ADDENDUM NO. 1
To Drawings and/or Specifications for
Newark High School Tennis Courts - BID#CSD – 2012-05

February 13, 2012

ADDENDUM #1 BY LANDMARK ENGINEERING, INC.
100 W. COMMONS BOULEVARD, NEW CASTLE, DE 19720

36 AND 60 FOOT TENNIS STRIPING PLAN

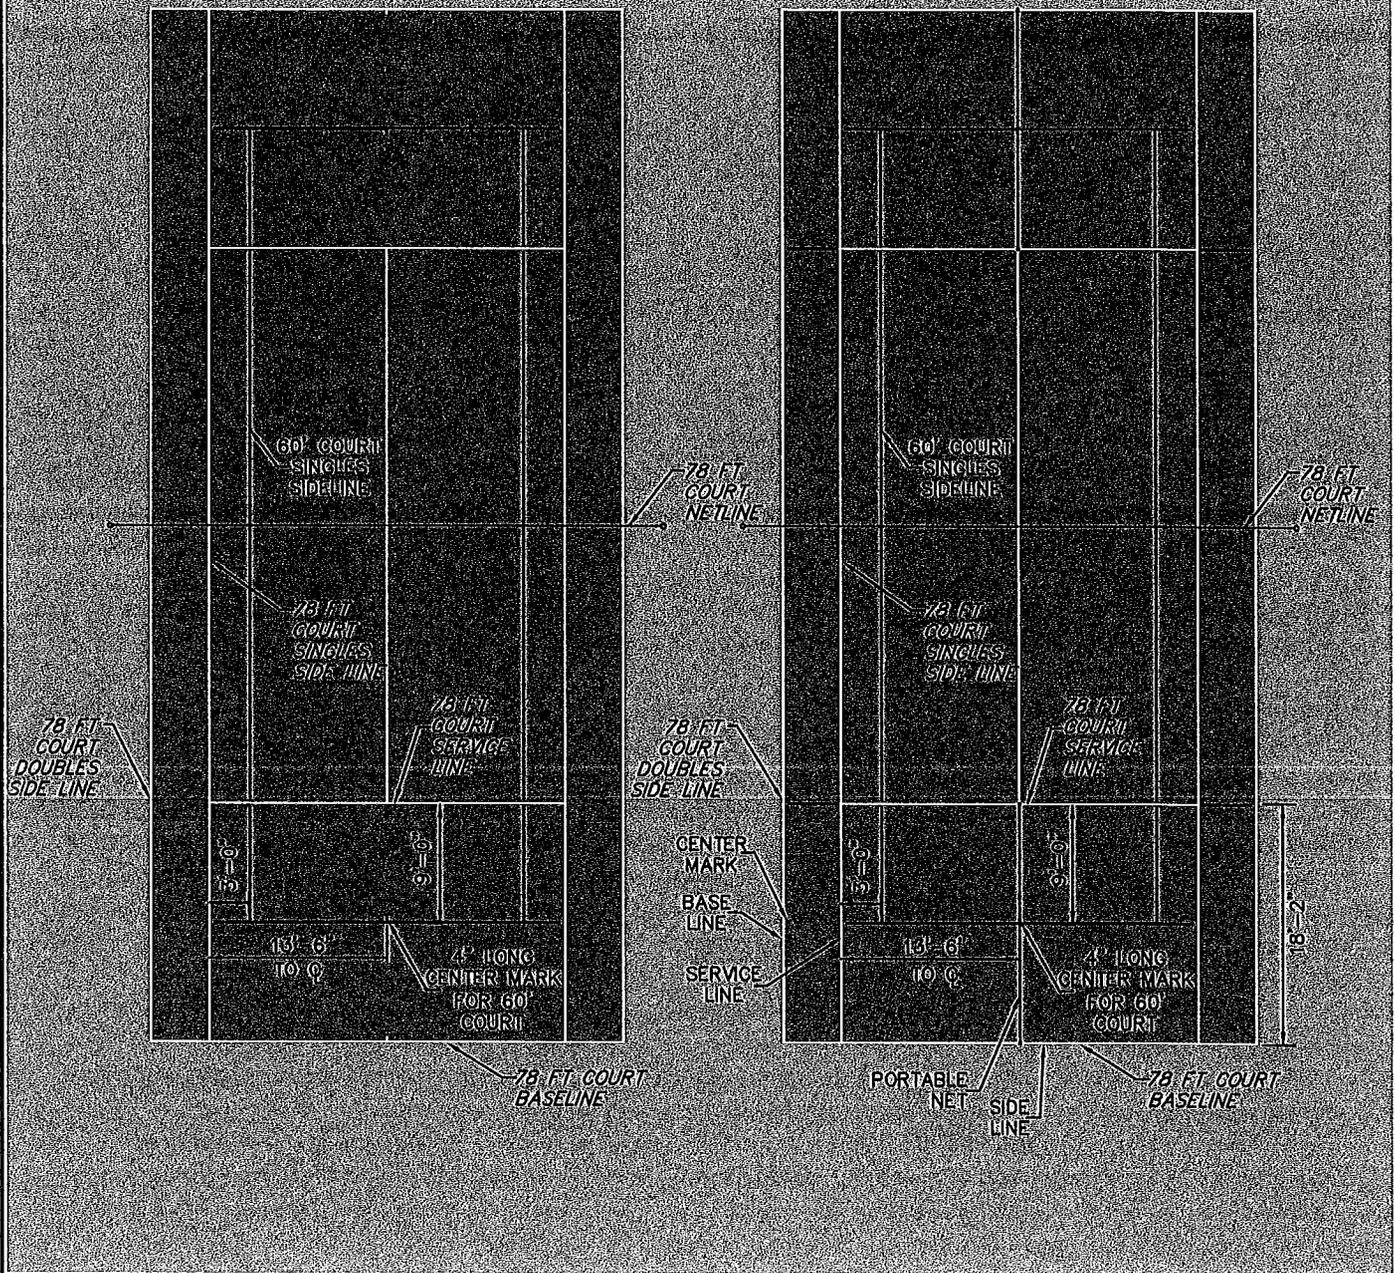
Supplemental striping for the tennis courts as shown on the plans and the supplemental drawings.

1. 10 AND UNDER TENNIS PLAYING LINES SHALL BE TEXTURED LINE PAINT WITHIN THE SAME FAMILY AS THE 78 FOOT COURT COLOR.
2. ALL 10 AND UNDER TENNIS PLAYING LINES SHALL TERMINATE 3 INCHES FROM THE 78 FOOT COURT LINES.
3. ALL 10 AND UNDER TENNIS PLAYING LINES SHALL BE 1 1/2" WIDE.
4. ALL 10 AND UNDER TENNIS PLAYING LINES SHALL BE MEASURED OUT TO OUT, WITH THE EXCEPTION OF THE CENTER LINES WHICH SHALL BE MEASURED OUT TO CENTER.
5. THE CENTER MARK FOR THE 36 FOOT COURT SHALL BE SET 2 INCHES OFF THE 78 FOOT COURT DOUBLES SIDE LINE AND SHALL BE 2 INCHES LONG BY 1 1/2" WIDE.
